MILLSTONE POWER STATION UNIT 2

SIX-MONTH STATUS REPORT IN RESPONSE TO MARCH 12, 2012 COMMISSION ORDER MODIFYING LICENSES WITH REGARD TO REQUIREMENTS FOR MITIGATION STRATEGIES FOR BEYOND-DESIGN-BASIS EXTERNAL EVENTS (ORDER NUMBER EA-12-049)

Six-Month Status Report for the Implementation of Order EA-12-049, Order Modifying Licenses with Regard to Requirements for Mitigation Strategies for Beyond-Design-Basis External Events

FIGURE 10

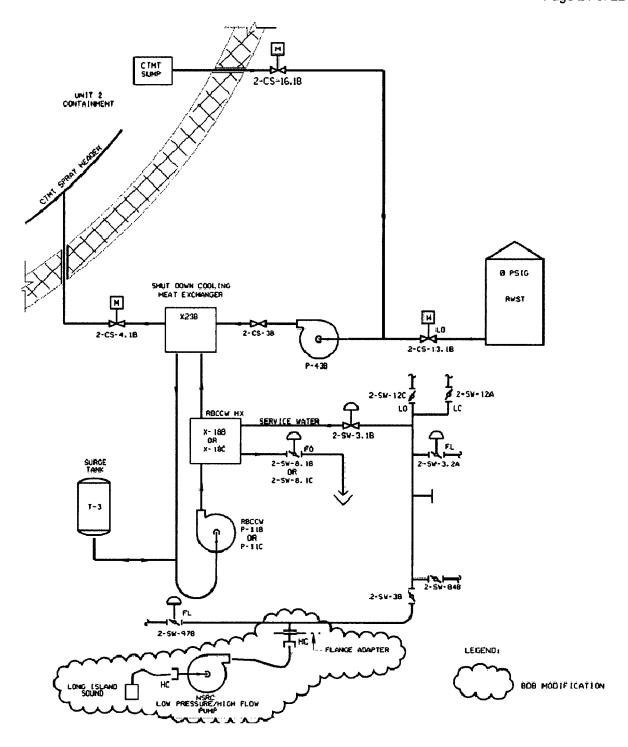
The tie-in location for the NSRC High Capacity / Low Pressure pump that is used to supply cooling water from Long Island Sound for either the primary or the alternate Containment cooling strategy was incorrectly identified in OIP Figures 10 and 11 provided in the February 2014 Six Month Status Update (Reference 3). These figures have been revised and included at the end of this attachment.
